Service Bulletin

No. : MZ02-002

Model: SA8260

Subject: Problem with playability of SACD and CD

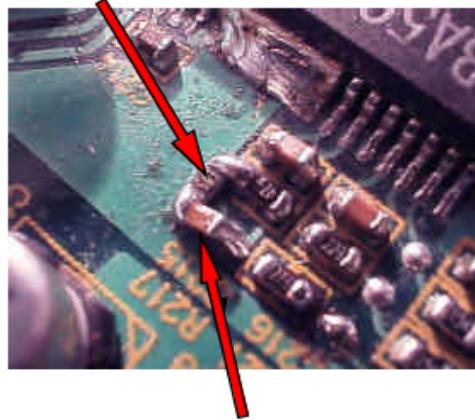
N0.19 (R378) add solder to R217

N0.26 (L132)

N0.25 (L131)

N0.25 (L131) is removed, and this is used N0.26 (L132)

N0.21 (C363) add

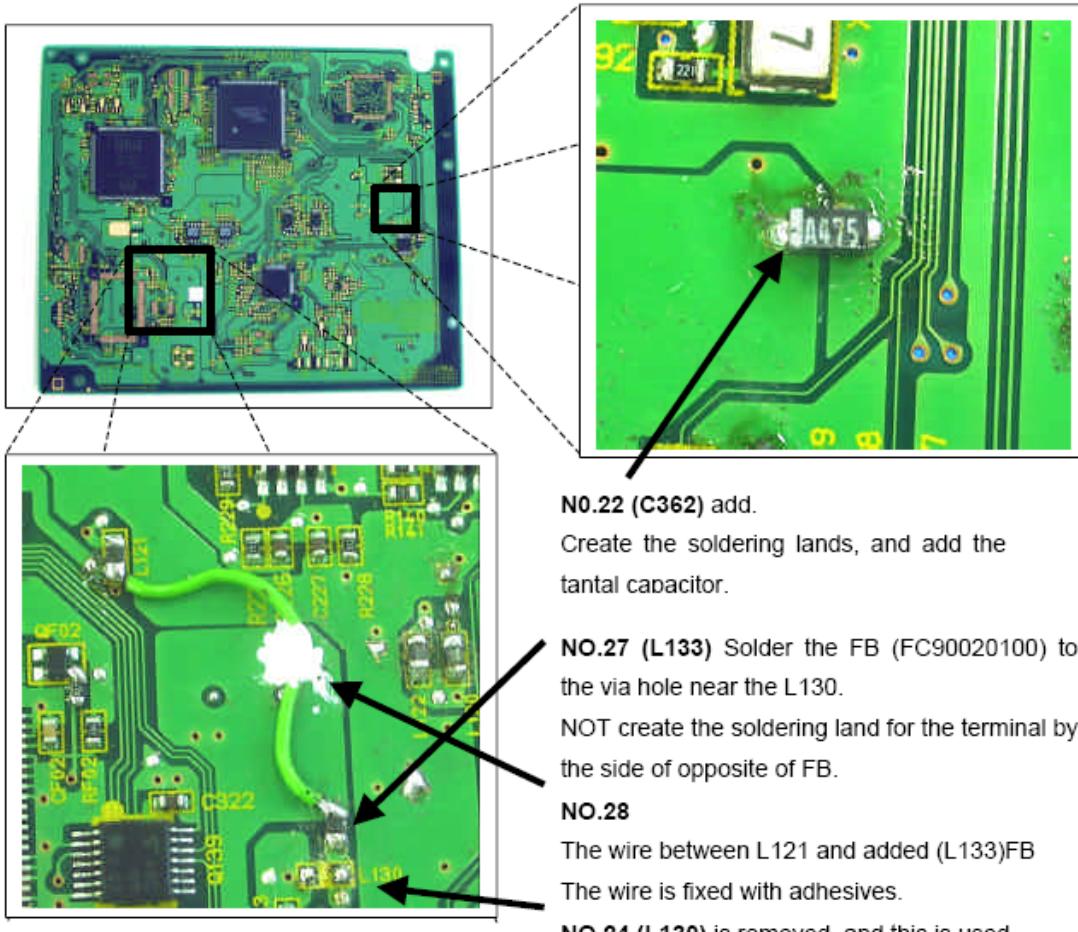
Solder to checker land side of R218,
the other hand solder to R378.

N0.22 (C362) add.

Create the soldering lands, and add the tantalum capacitor.

N0.27 (L133) Solder the FB (FC90020100) to the via hole near the L130.

NOT create the soldering land for the terminal by the side of opposite of FB.

N0.28

The wire between L121 and added (L133)FB

The wire is fixed with adhesives.

N0.24 (L130) is removed, and this is used

N0.27 (L133)
